ADDENDUM No. 3

REQUEST FOR QUOTATIONS No.:	1220-040-2022-049
TITLE:	Surrey Sports and Leisure Complex Roof Replacement Phase 1
ADDENDUM ISSUE DATE:	June 29, 2022
DATE	PREFER TO RECEIVE SUBMISSION ON OR BEFORE JULY 6 th , 2022.

Photo: Health Centre-interior

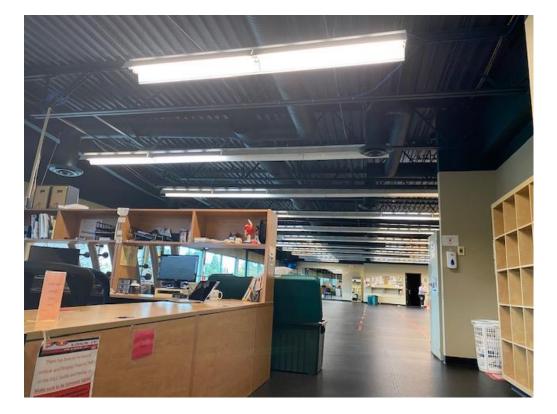
- **Q1.** Are we able to have a second site visit to see the space? How would you like us to propose the pricing for the additional work?
- A1. We are unable to facilitate another site visit, please refer to photos and drawings below. The Roof Area 3.1 is over the Health Centre (second floor) and has rooms below where the roof structure is exposed – refer to attached photos and reflected ceiling plan (drawing 4 of 7). Contractor to provide a separate price for the interior protection of these rooms. This is a leased/business space; contractor's access would have to be coordinated by the City.
